## RV dwellers can park on private property in residential areas under new ordinance

**From:** [Tanner, Rachael](#)  
**To:** [David Rogosa](#)  
**Cc:** [Planning Commission](#)  
**Subject:** RE: 985 Channing. Follow-up commentary and materials from Oct 13 deliberations, D Rogosa  
**Date:** Wednesday, November 24, 2021 1:03:59 PM  
**Attachments:** [DRogosaPTC11-10.pdf](#)  
[image001.png](#)  
[image002.png](#)  
[image004.png](#)  
[image005.png](#)  
[image006.png](#)  
[image007.png](#)

DUNLAP RESIDENCE

985 CHANNING AVENUE  
 PALO ALTO, CA 94301

2 PROPOSED ROOF PLAN  
1/4"=1'-0"

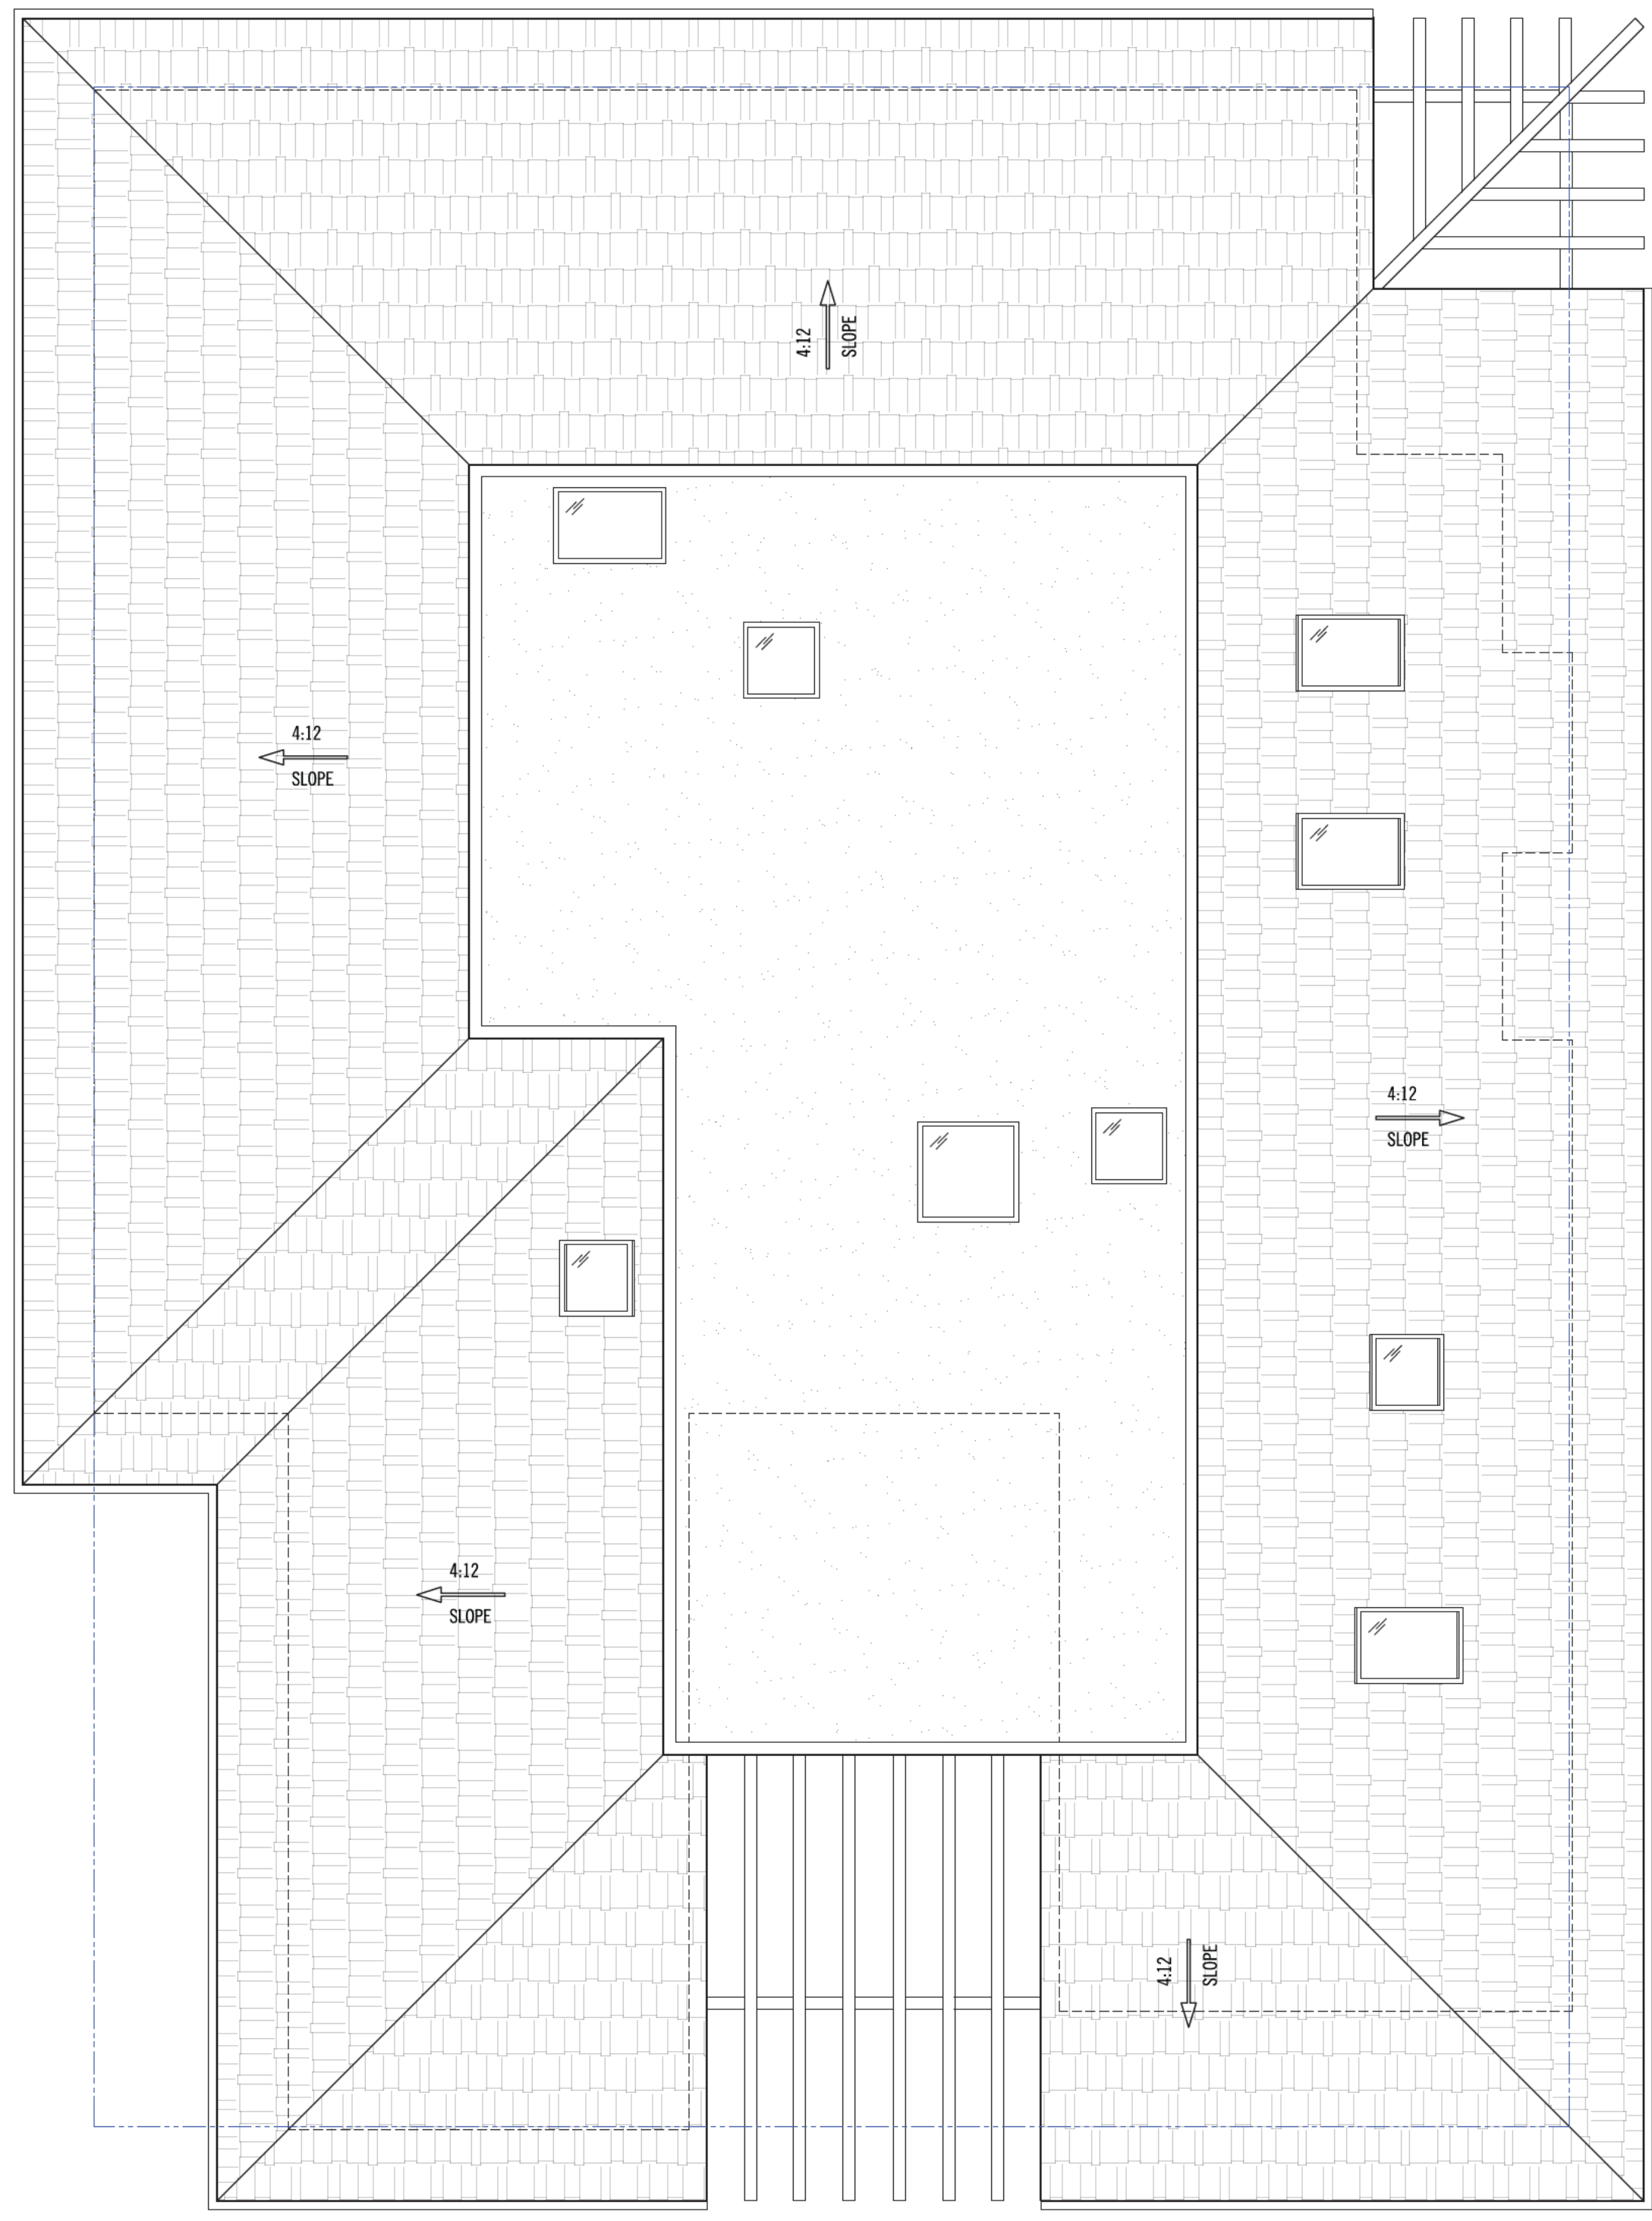
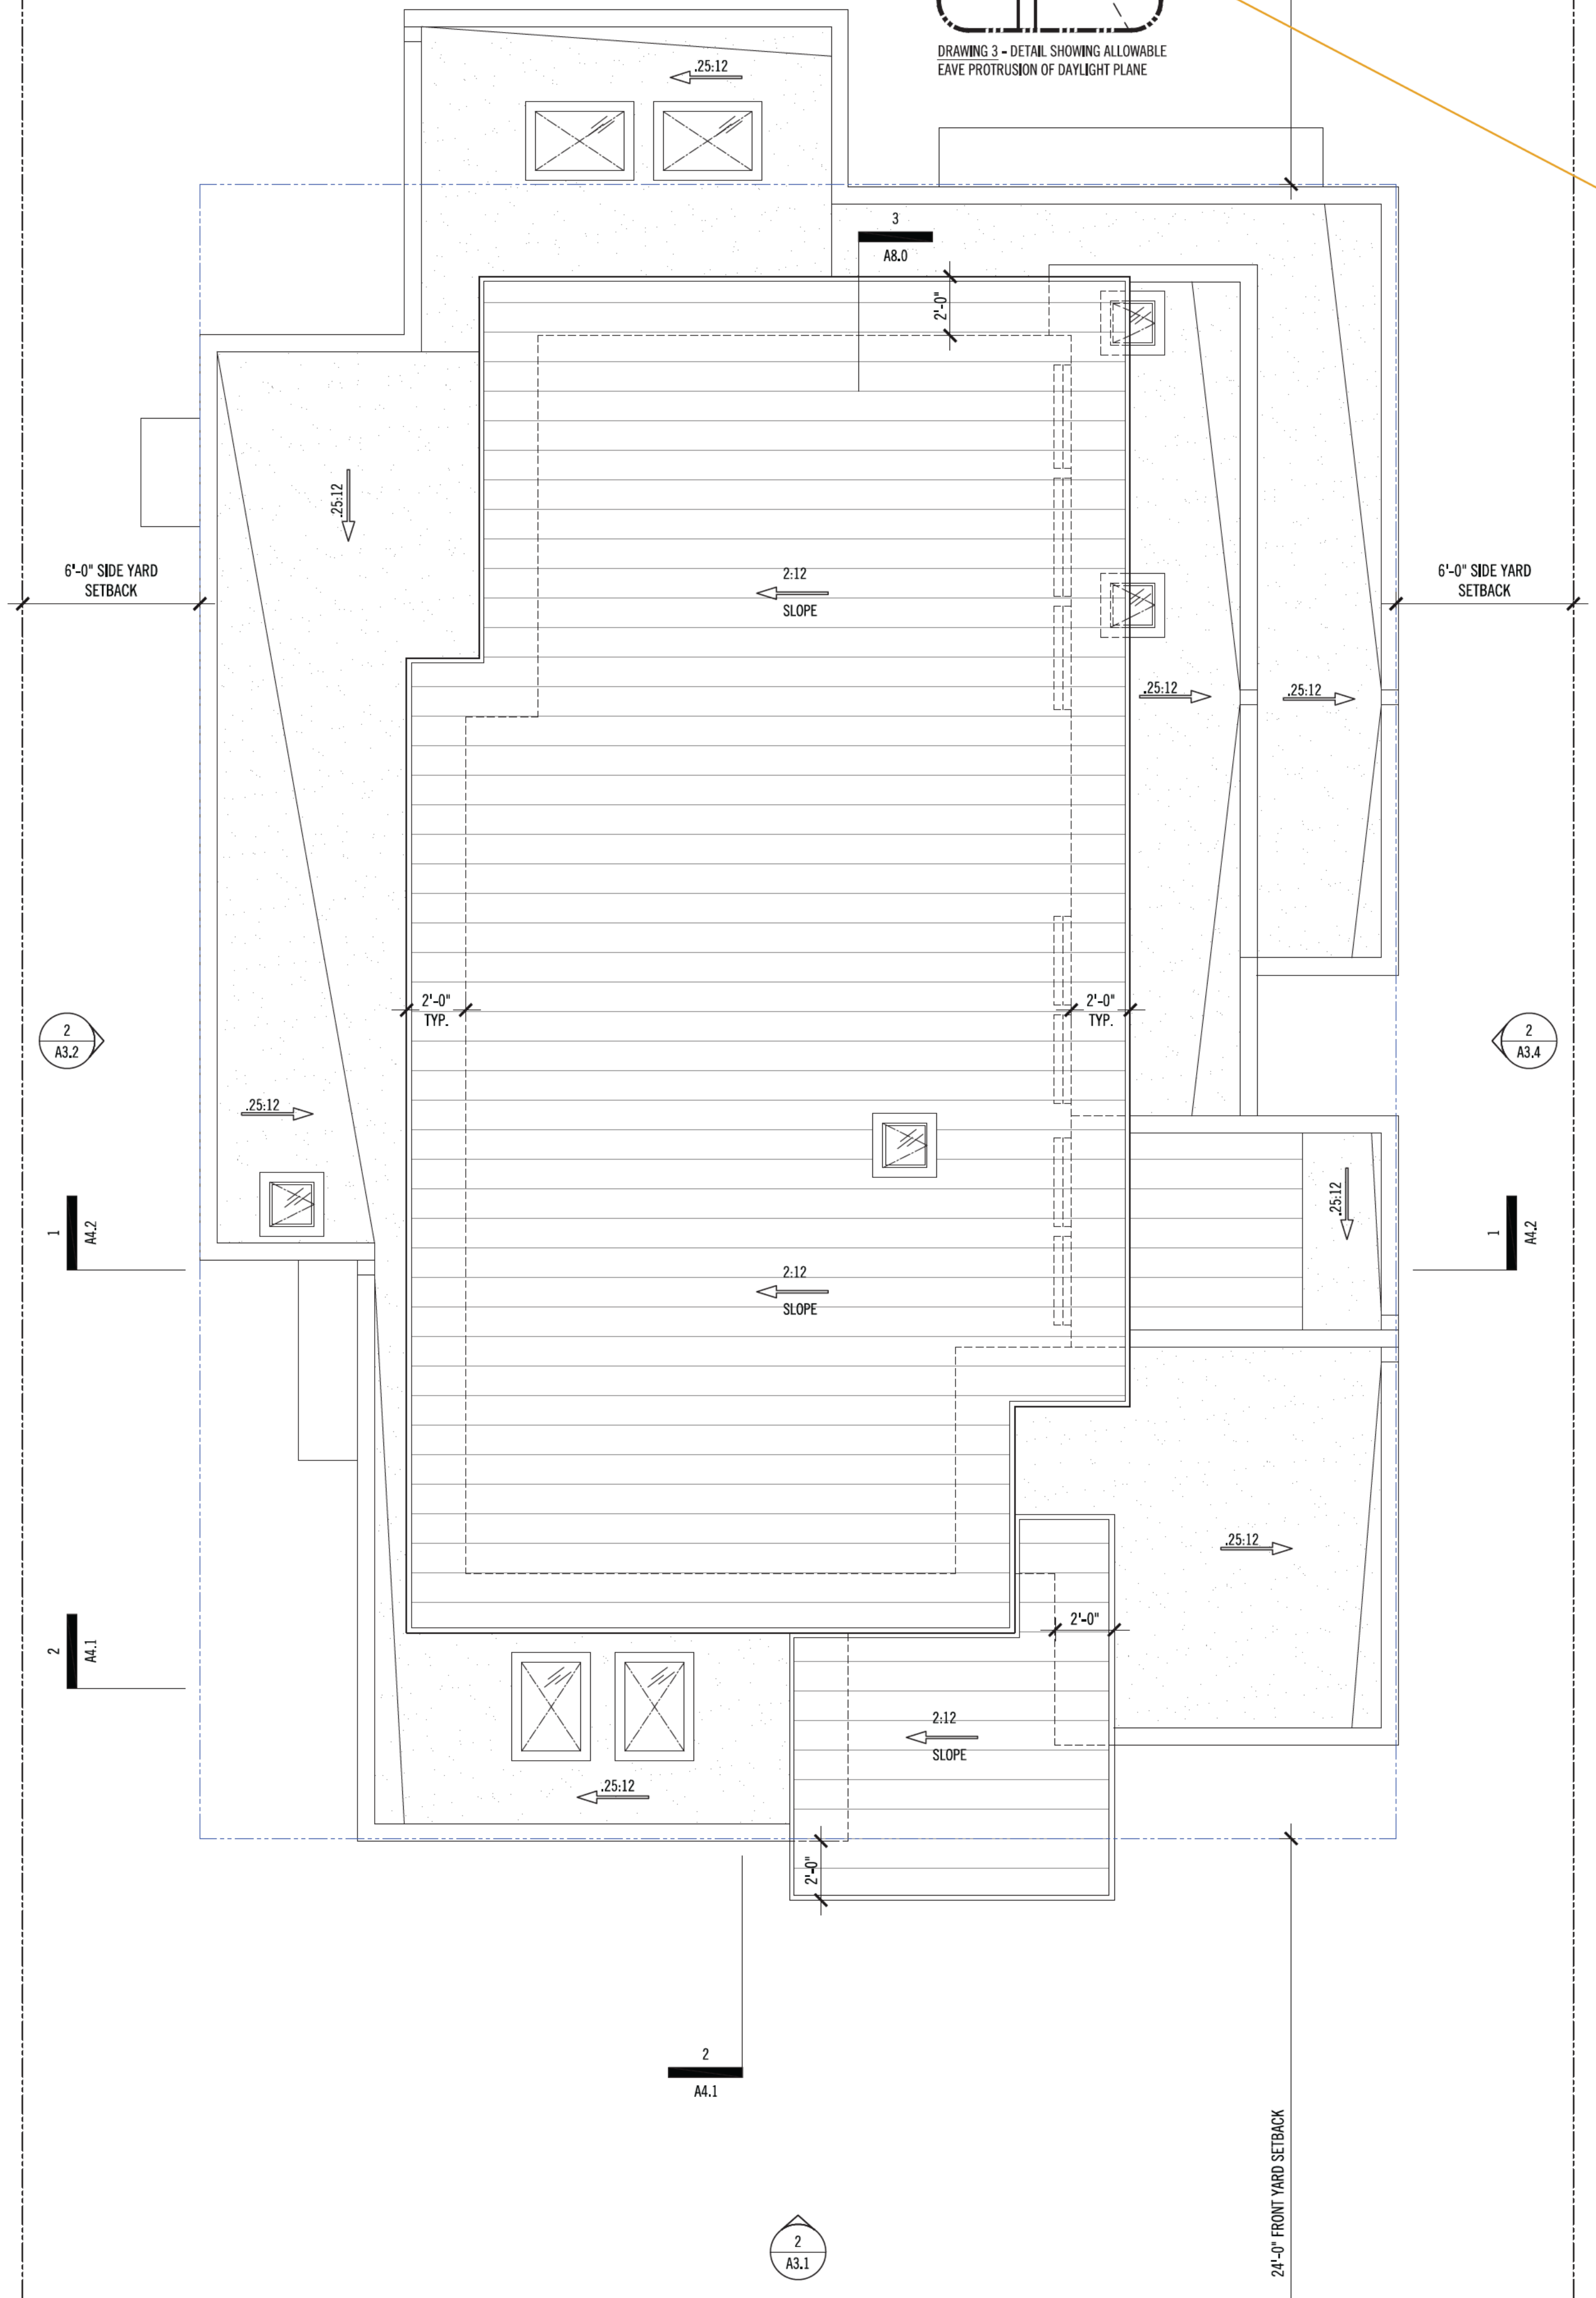
Clarify outline of drawing to identify top of roof and bottom of roof slope.
